HISTORIC AND DESIGN REVIEW COMMISSION

February 07, 2018

HDRC CASE NO: 2018-048
ADDRESS: 210 W LYNWOOD
LEGAL DESCRIPTION: NCB 6384 BLK 4 LOT 16 THRU 21
ZONING: R-5 H
CITY COUNCIL DIST.: 1
DISTRICT: Monte Vista Historic District
APPLICANT: Brett Ingram/Ingram Roofing & Construction
OWNER: Roger & Jacqueline Hill
TYPE OF WORK: Roof replacement, window replacement
APPLICATION RECEIVED: January 19, 2018
60-DAY REVIEW: March 20, 2018
REQUEST:

Exhibit 1
Existing Aluminum
Windows on Front Left
Elevation

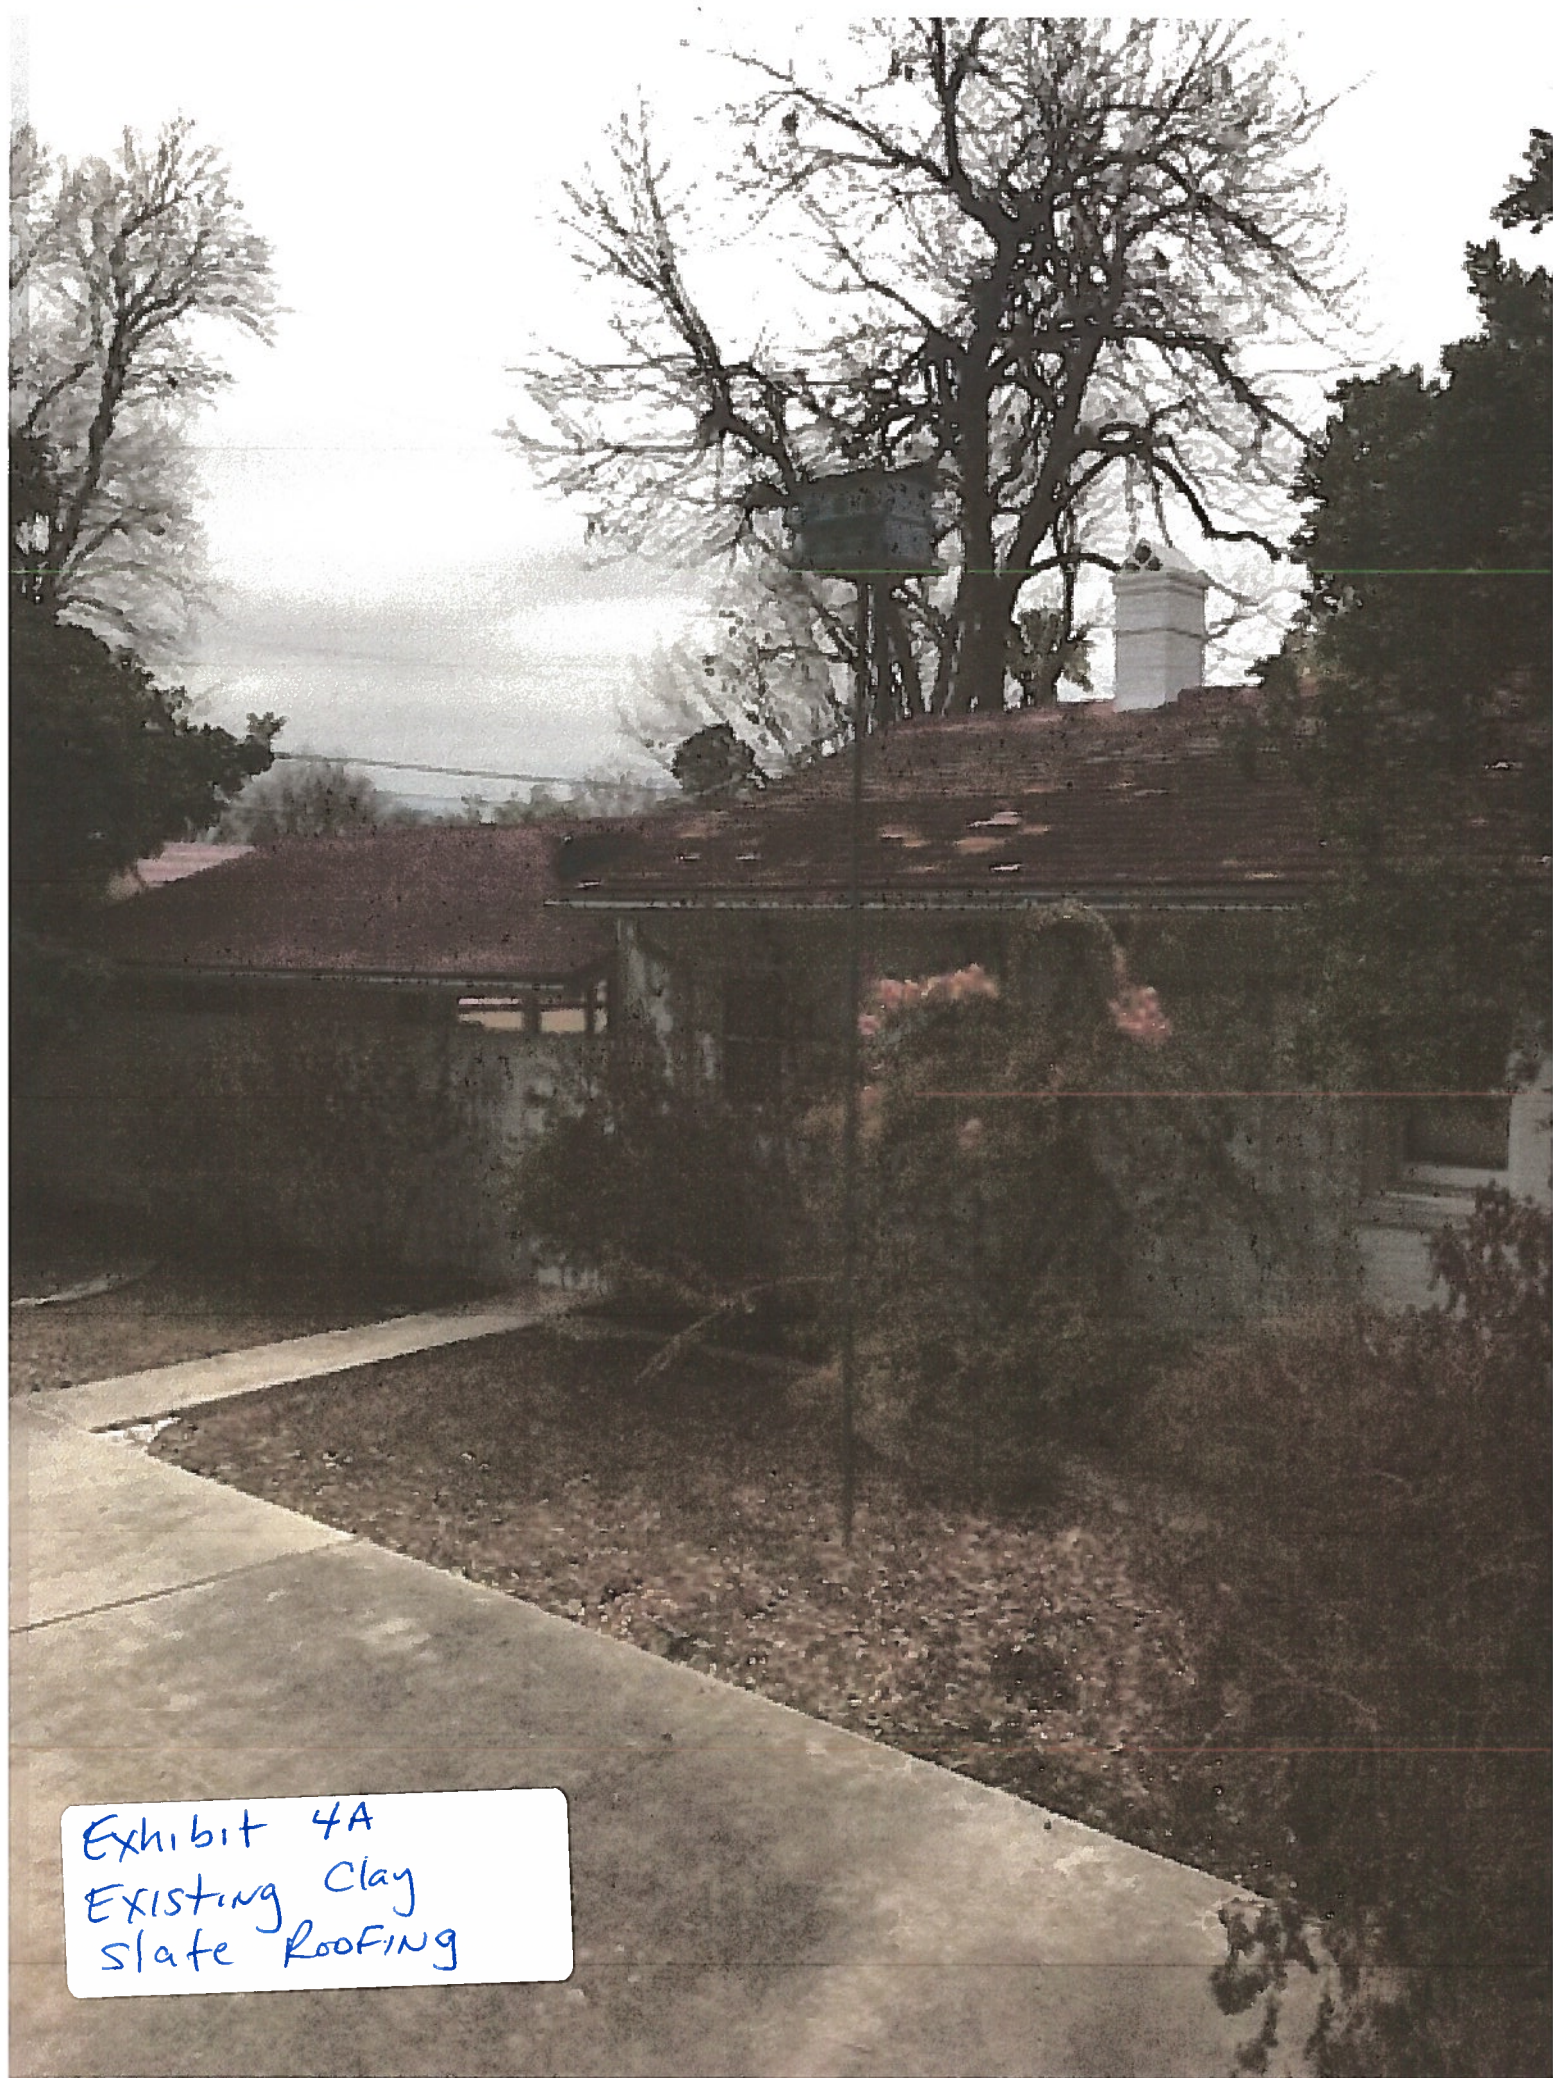
- b. **WINDOW SCREEN REPLACEMENT** – The applicant has proposed to replace existing non-original aluminum window screens on a side porch addition with five sets of new hybrid wood and vinyl casement windows. The new windows will feature 6 divided lites to match existing window patterns on the home. The window modification will also add new board and batten siding beneath the openings. According to the Historic Design Guidelines, non-historic incompatible windows with should be replaced with windows that are typical of the architectural style of the building. Staff finds the proposed window proportions and configurations to be a significant upgrade to the current condition of the porch, which is located at the corner of the lot and visible from the public right-of-way. The proposal is also an upgrade from the existing metal screens and framing. Staff finds that hybrid wood and vinyl windows may be appropriate for replacing incompatible metal windows if the windows meet all the required specifications listed in the recommendation.

Item 1, Staff recommends approval of the window replacement based on finding b with the following stipulations:

- i. That the windows feature true divided lites or lites that are raised from the exterior glass. Faux divided lites or lites internal to the window panes are not appropriate. The applicant is required to submit a final window specification, including section detail, to staff prior to receiving a Certificate of Appropriateness.
- ii. That the board and batten siding features boards that are twelve (12) inches wide with battens that are 1 – ½” wide.

Exhibit
4A+4B

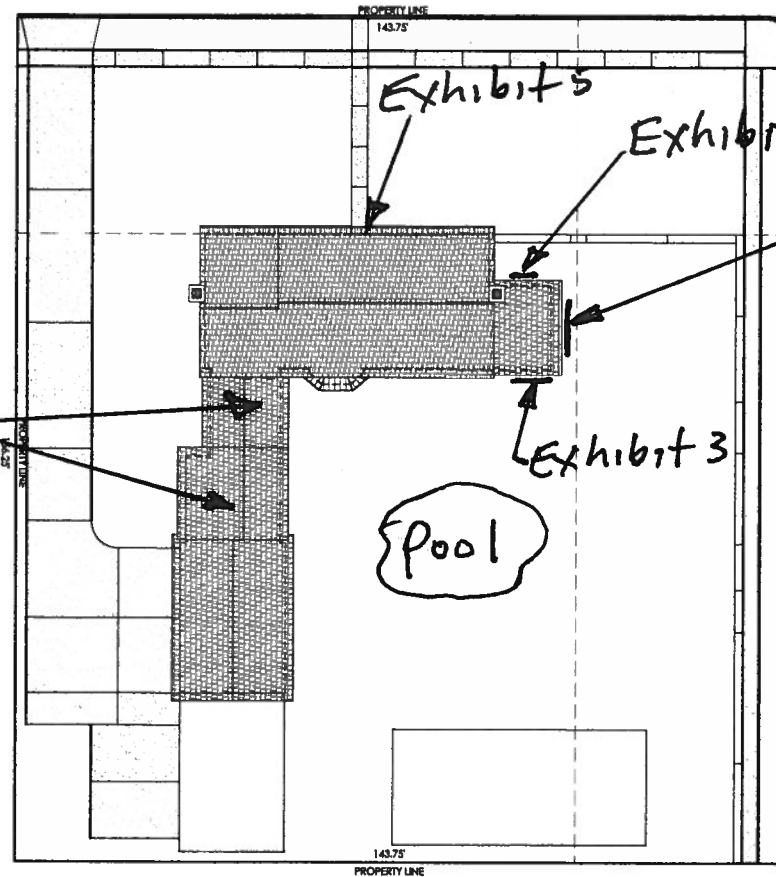
- c. **ROOF REPLACEMENT** – The applicant has proposed to replace the existing flat, terra cotta colored clay tile roofing on both the primary and accessory structures with a new standing seam galvalume metal roof in the color charcoal. According to the Guidelines for Exterior Maintenance and Alterations 3.B.iv., roofing materials should be replaced in-kind whenever possible when the roof must be replaced. Historic materials should be retained and

reused when large-scale replacement of roof materials is required, specifically roofs constructed of slate or clay tile. New roofing materials should match the original materials in terms of their scale, color, texture, profile, and style. The clay tile roofs are character defining features of the style and materiality of the structures. Additionally, clay tiles, including barrel tiles and flat tiles, are historically common on houses of various styles on W Lynwood, as well as to the south on W Elsmere Place. Staff finds that a standing seam metal roof would substantially alter the style and visual elements of the home.

Item 2, Staff does not recommend approval of the roof replacement. If roof replacement is required, staff recommends that the roof be replaced in-kind.
